from
**Southern
Water**

Your ref
APP/20/00913

Proposal: Demolition of existing buildings in a conservation area and erection of 2 No. 3 bed houses, 1 No. 1 bed apartment and 1 No. 2 bed maisonette.

Site: APP/20/00913: - 10A, The Pallant, Havant, PO9 1BE.

Southern Water MapGuide Browser

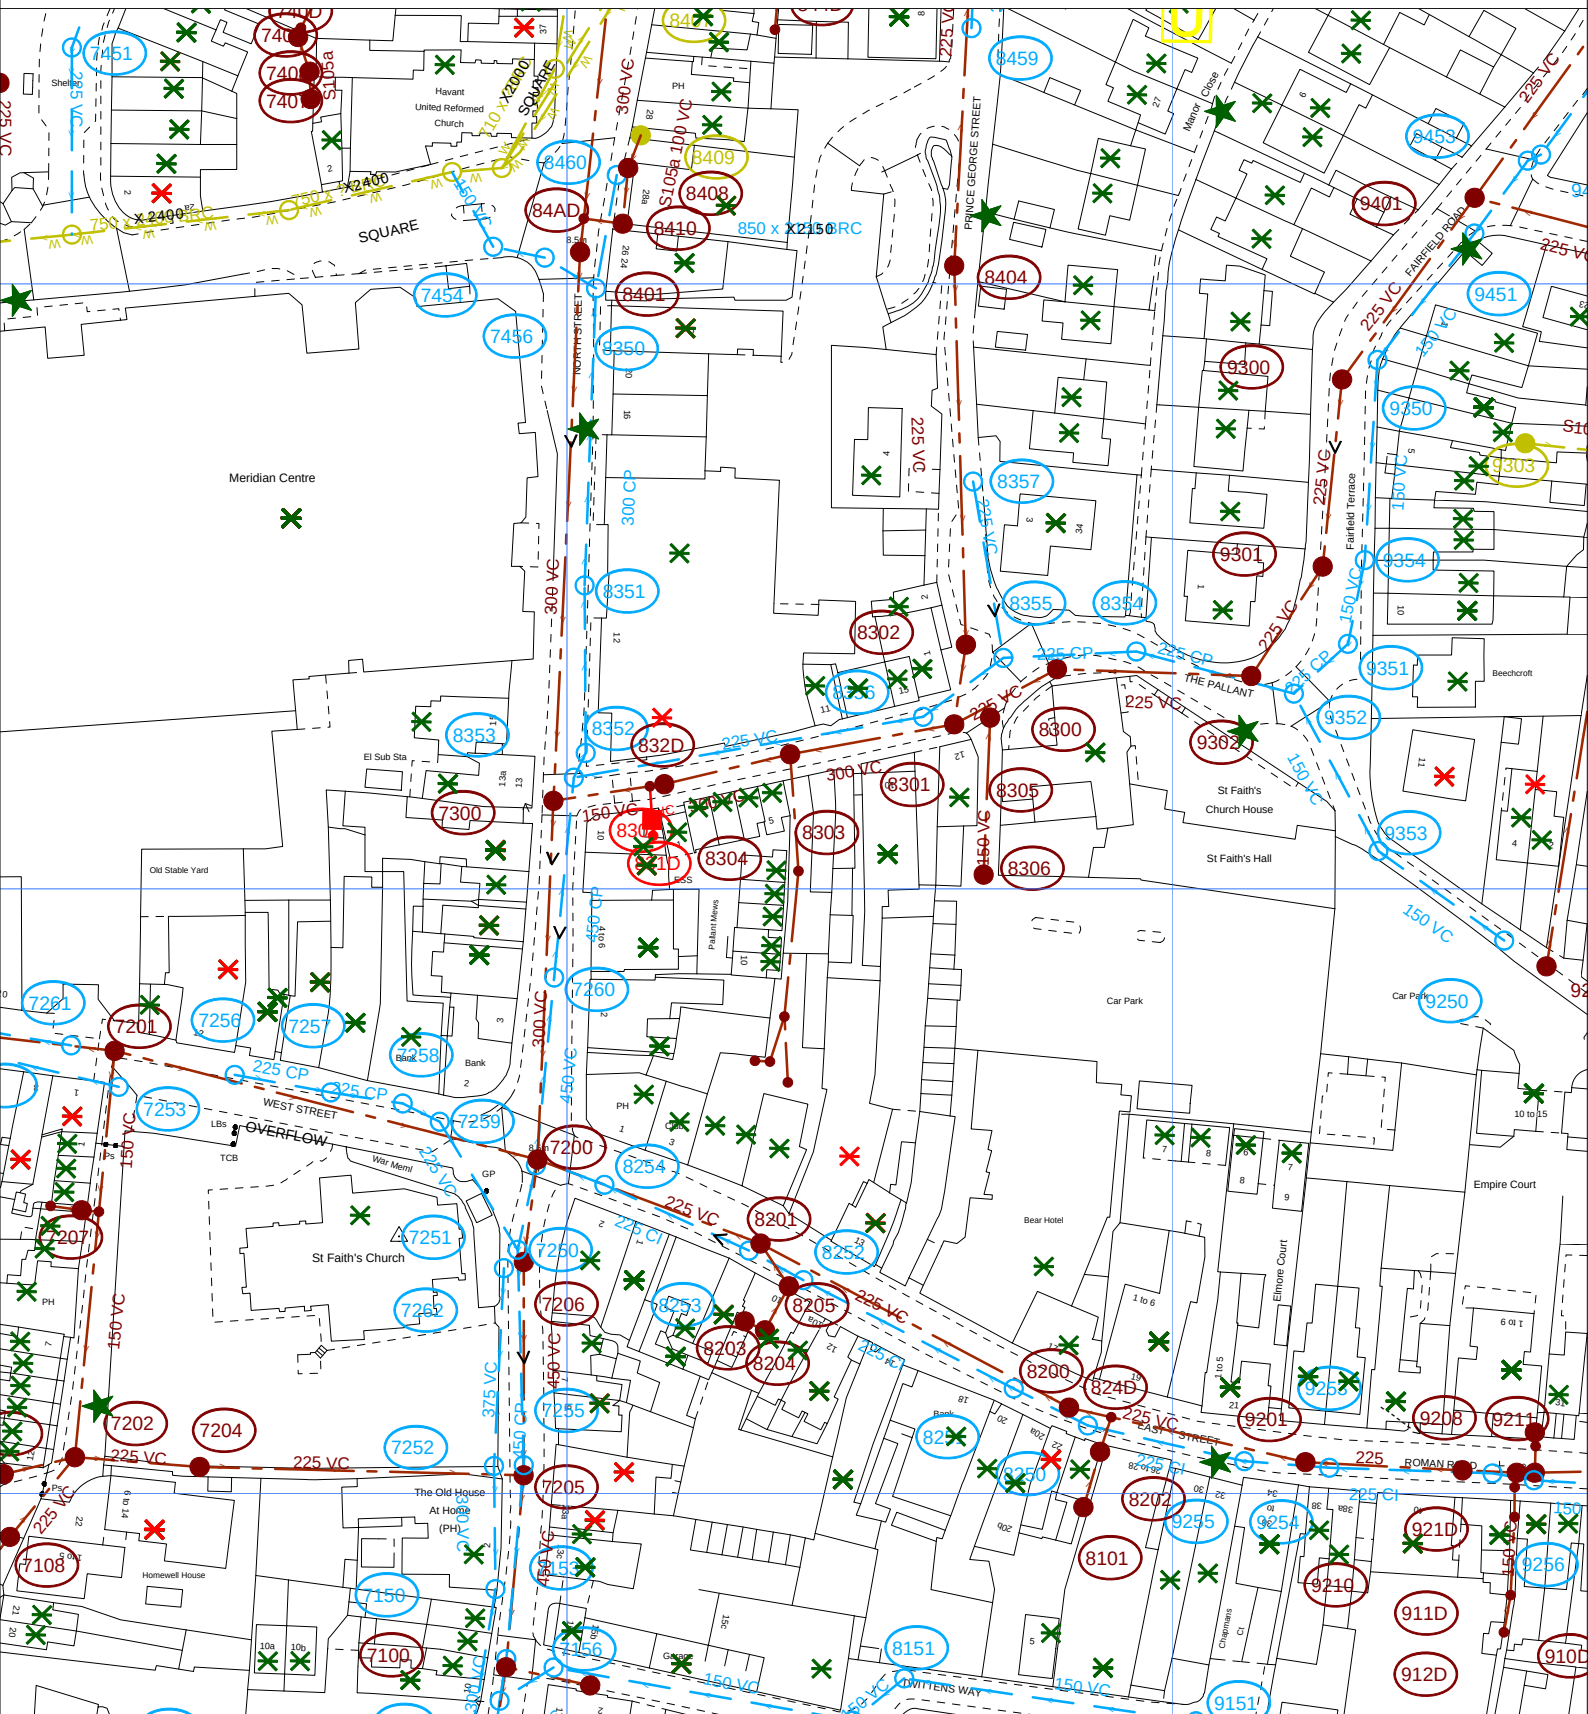
Please find attached a plan of the sewer records showing the approximate position of a public sewers within the site. The exact position of the public sewers must be determined on site by the applicant before the layout of the proposed development is finalised.

- The gravity sewer requires a clearance of 3 metres on either side of the gravity sewer to protect it from construction works and to allow for future maintenance access.
- No development or tree planting should be carried out within 3 metres of the external edge of the public gravity sewer without consent from Southern Water.
- No soakaway, swales, ponds, watercourses or any other surface water retaining or conveying features should be located within 5 metres of a public sewer.
- All existing infrastructure should be protected during the course of construction works. Please refer to: southernwater.co.uk/media/default/PDFs/stand-off-distances.pdf

In order to protect public sewers, Southern Water requests that if consent is granted, the following condition is attached to the planning permission; The developer must agree with Southern Water, prior to commencement of the development, the measures to be taken to protect the public sewers.
